**STAFF REPORT - DESIGN REVIEW E
FINDINGS AND RECOMMENDATION**

FILE NUMBER: DRE/VR2/TR/LL 17-26000203

PROPOSAL: Type III Design Review E for the construction of a 122-guestroom, four-story hotel with Type II Tree Removal, Minor Variance, Lot Line Adjustment and associated site improvements

Image 1: Proposed Primary Internal Drive (oriented north-south) and the existing Private Drive (oriented east-west) with a future connection to development to the north.

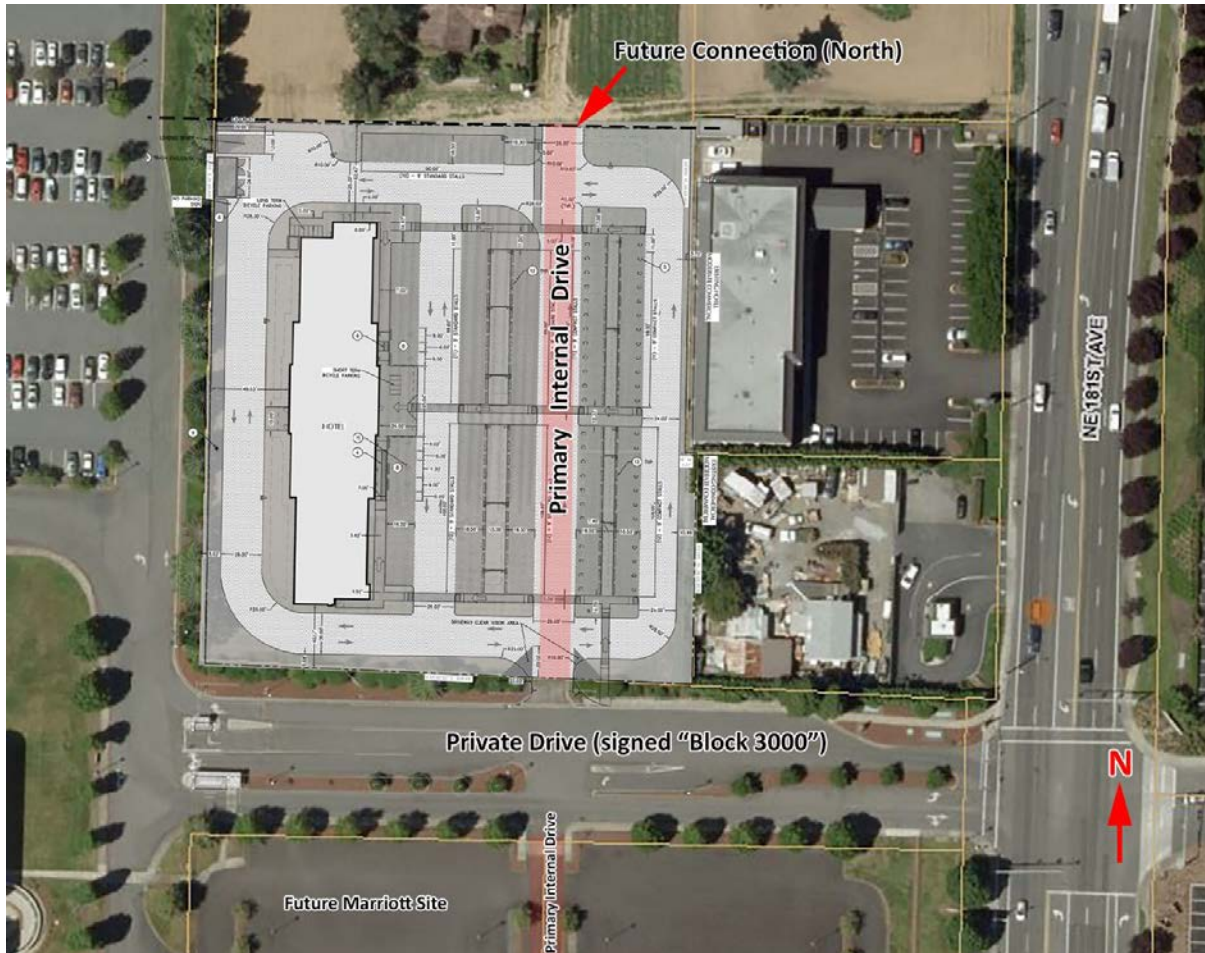
7.0603(A)(1)(c)(4) and 7.0603 (A)(1)(d)(4) - Vehicular and Pedestrian Connections. Staff concurs that the project will provide adequate vehicular and pedestrian connections through the site's parking lot to the future development to the north. Due to a grade change and existing retaining wall, a connection to the Hampton Inn property to the east is infeasible at this time and would result in limited utility to either property as it would reduce the number of parking stalls on the Hampton Inn property and would reduce the amount of landscaping and water detention area on the project site. A

condition of approval requiring a cross access easement to the property to the north shall be required and shall take effect when the adjacent property to the north is developed.

RECOMMENDATION: The intent of the guideline is to provide accommodation to pedestrian and vehicular access and to improve the appearance of the development. The applicant is proposing a pedestrian walkway that will not run parallel to the primary internal drive. The applicant has worked with staff to identify potential scenarios to provide a sidewalk abutting the primary internal drive. Due to the placement of the primary internal drive (designed to align with the primary internal drive to the south) and parking requirements for the hotel, inclusion of a north-south sidewalk directly adjacent to the internal drive, plus

required landscaping, may impede efficient circulation through the site; this results in potentially requiring a double loaded, narrow one-way drive aisle along the east side of the site with sharply angled compact stalls. In an alternative scenario, the primary drive would need to shift several feet to the west, reducing parking stall depths of the standard stalls (however, stall width would still be met with bumper overhangs into the landscape planter area) and allowing placement of the sidewalk adjacent to the drive aisle with compact stalls along the site's east side.

Staff recommends that the Design Commission waive the guideline.
